PEARL STREET GARAGE
UNIVERSITY OF MARYLAND AT BALTIMORE
BALTIMORE MARYLAND 21201 **UMAB PROJECT NO. 85 304 A**

Title: GRADING & UTILITY PLAN

Title
SECOND & THIRD
LEVEL PLANS

TITLE: TYPICAL (4, 5, 6) and ROOF STRIPING PLAN
Contract No. 85276C01
Scale: 1/16" = 1'-0"
Date: 3-1-87
Sheet: 06

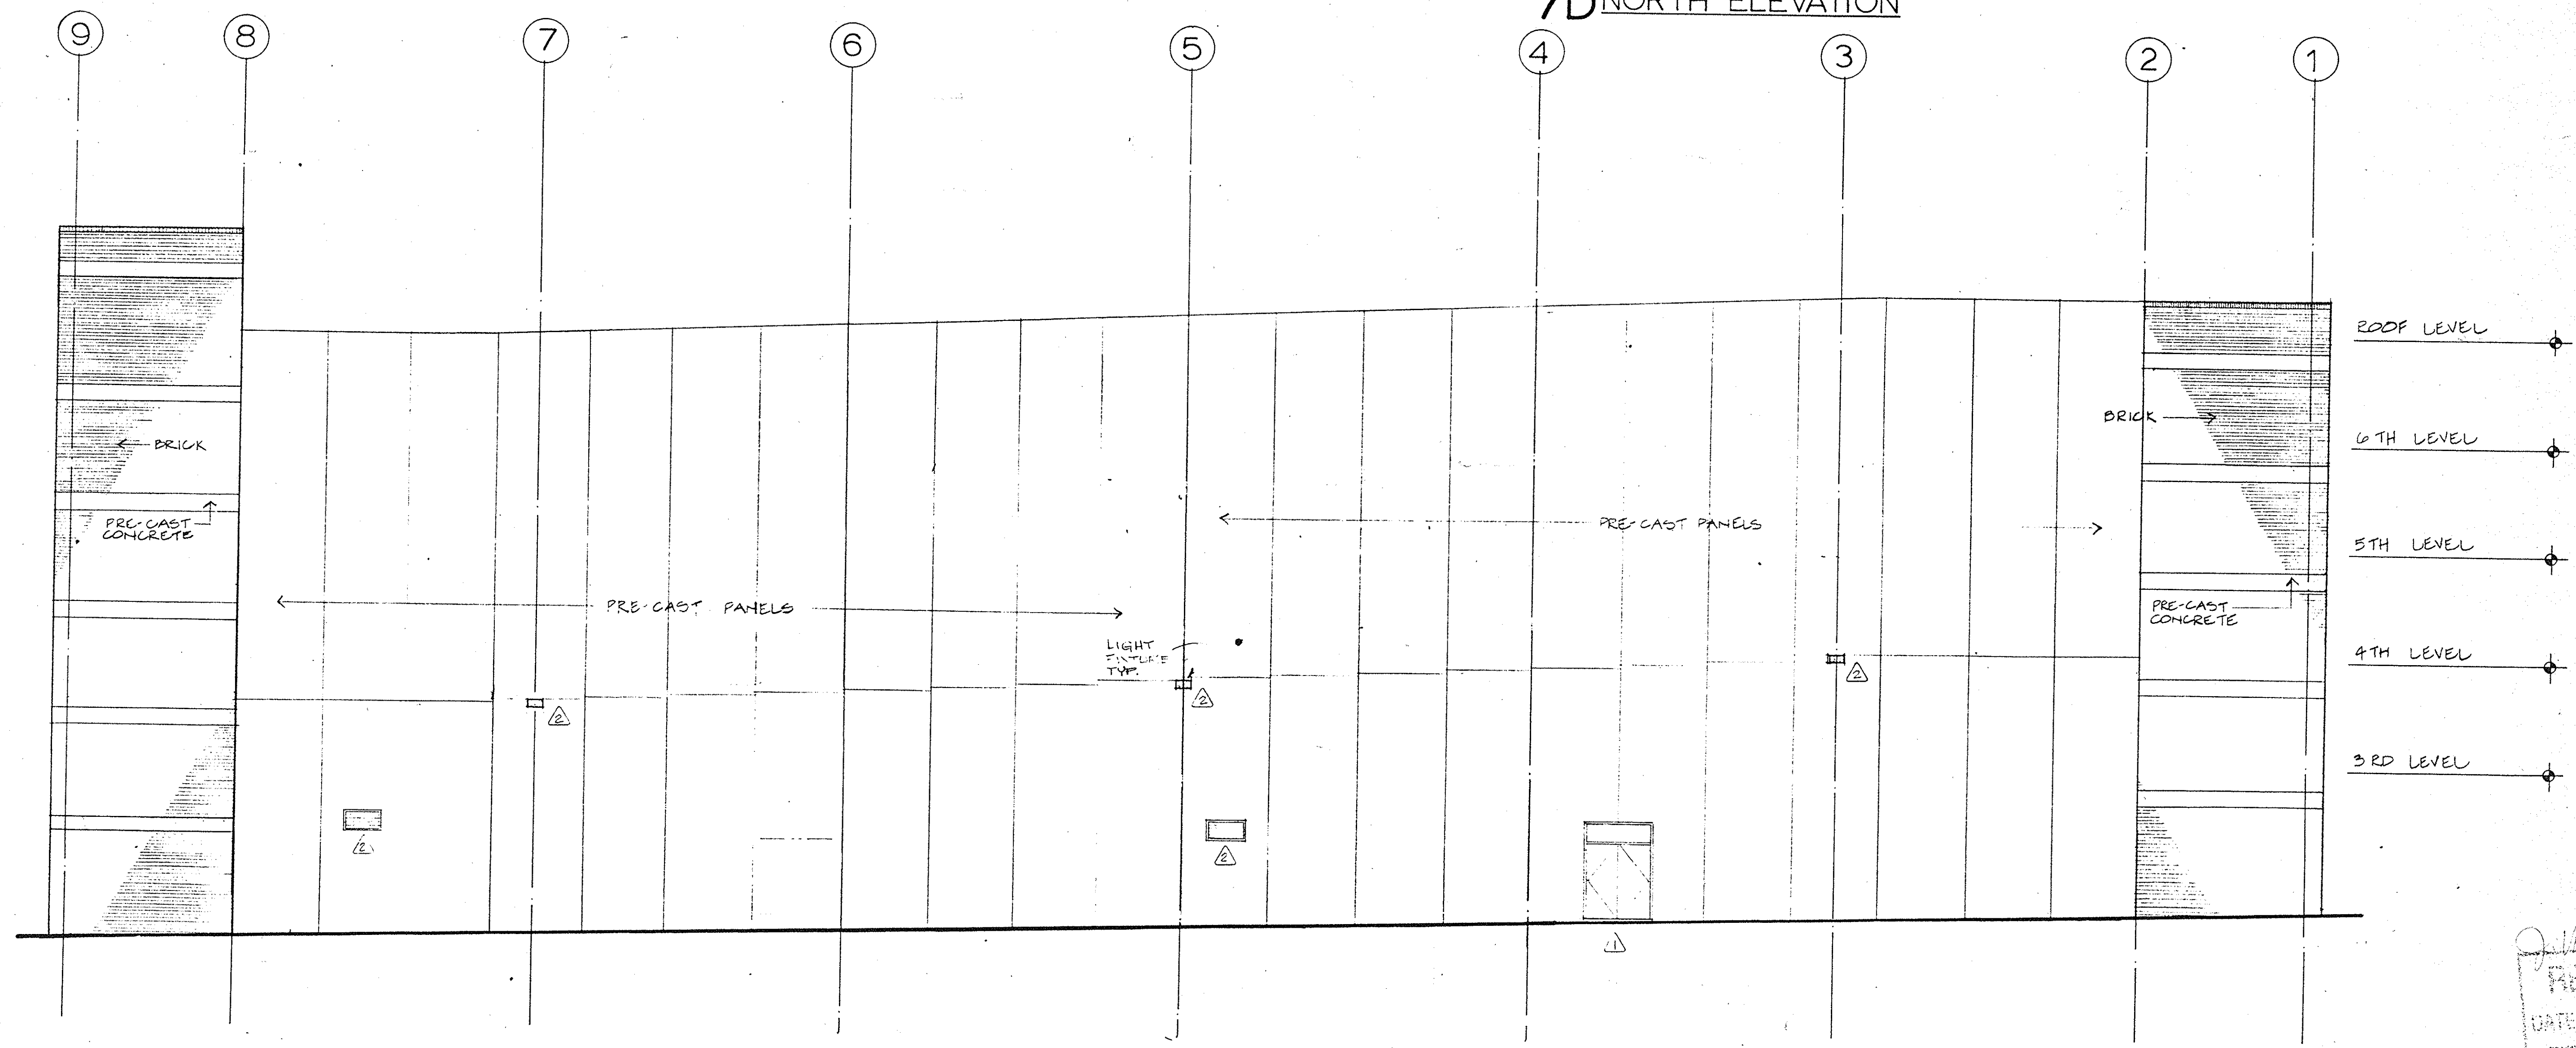
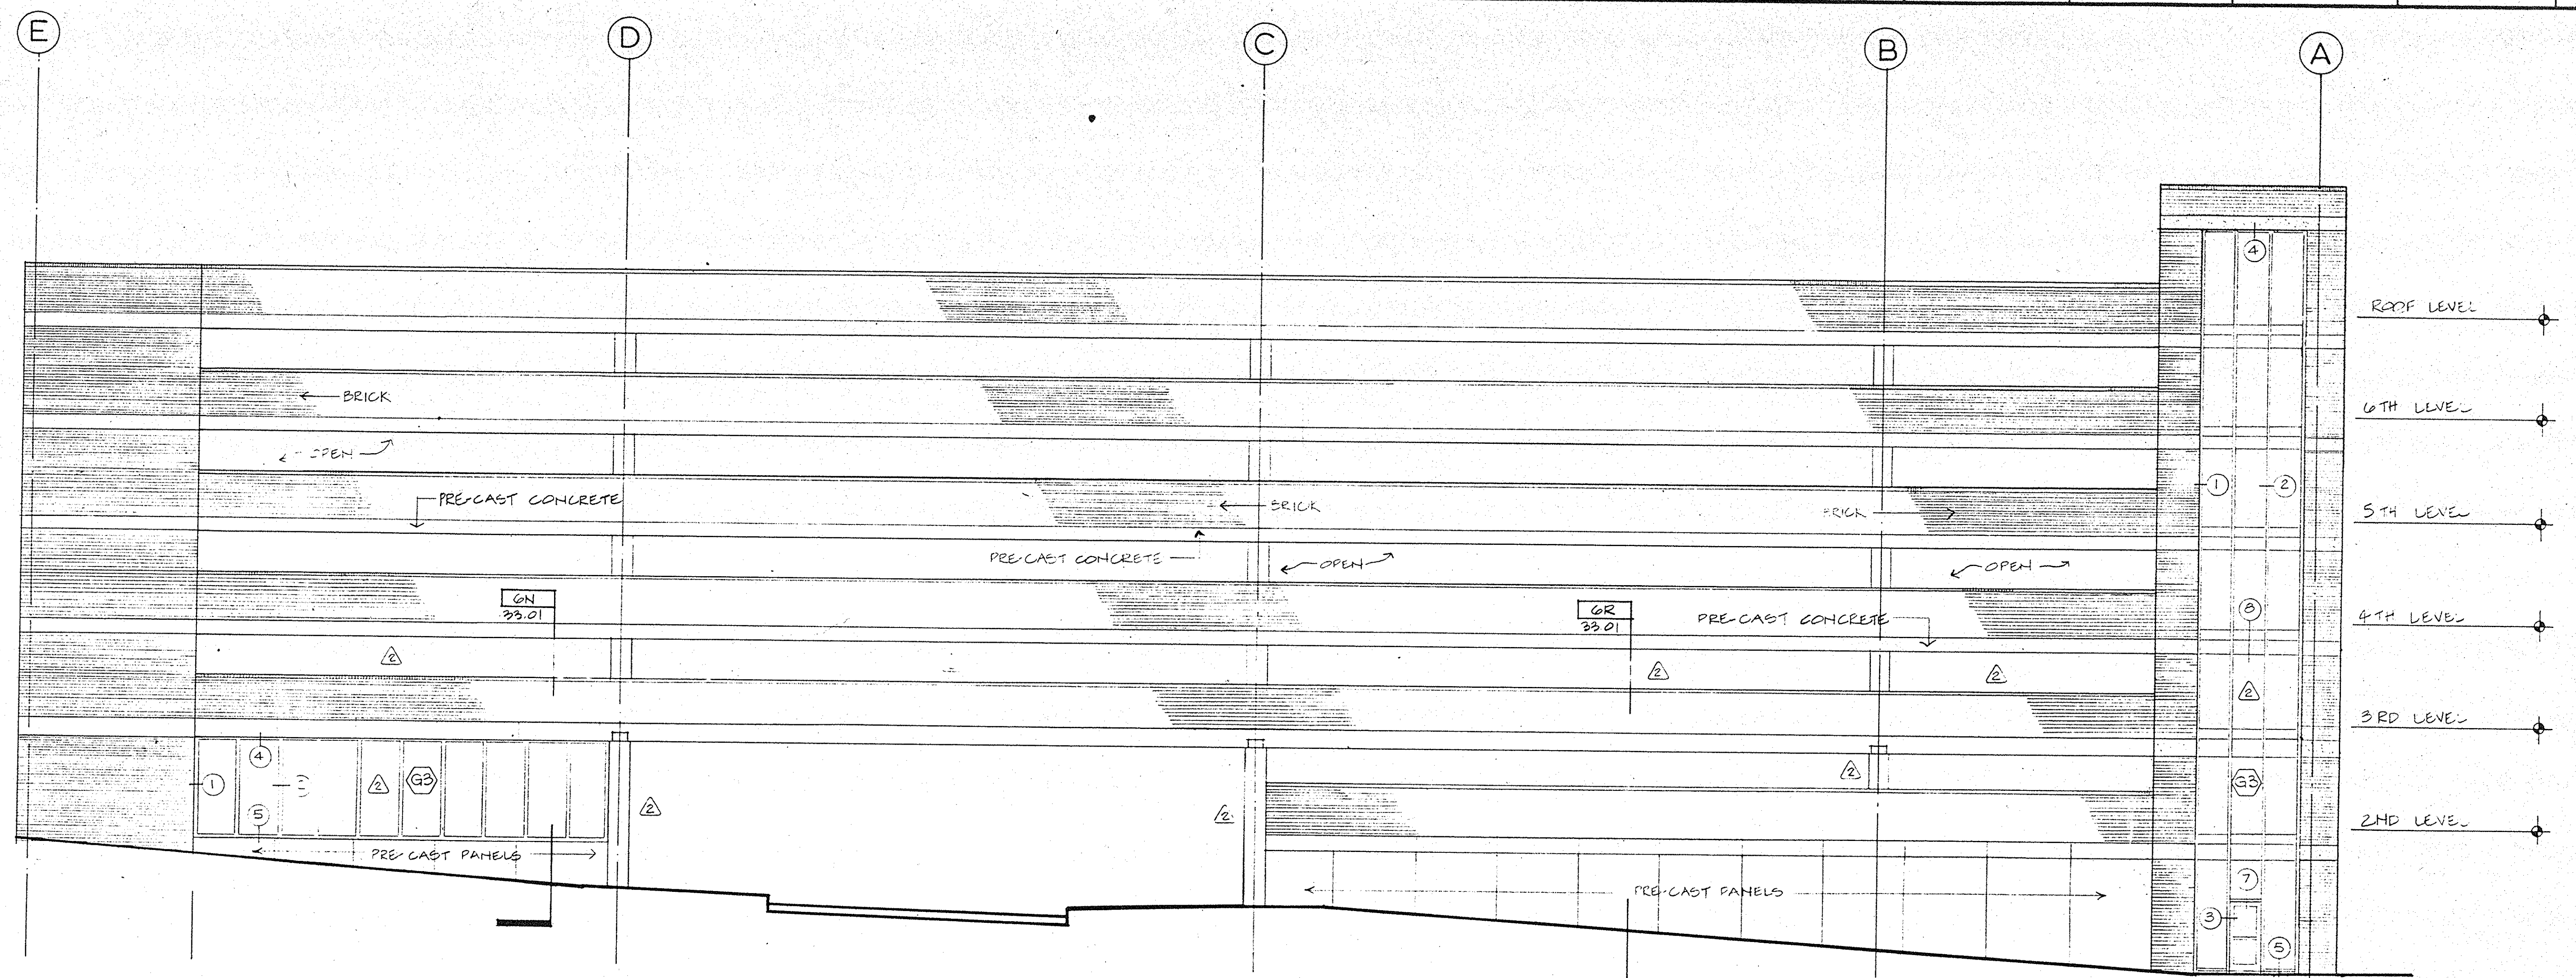
ELIMINATE
ALL HANDICAPPED
SPACES ON 4TH 5TH 6TH & ROOF
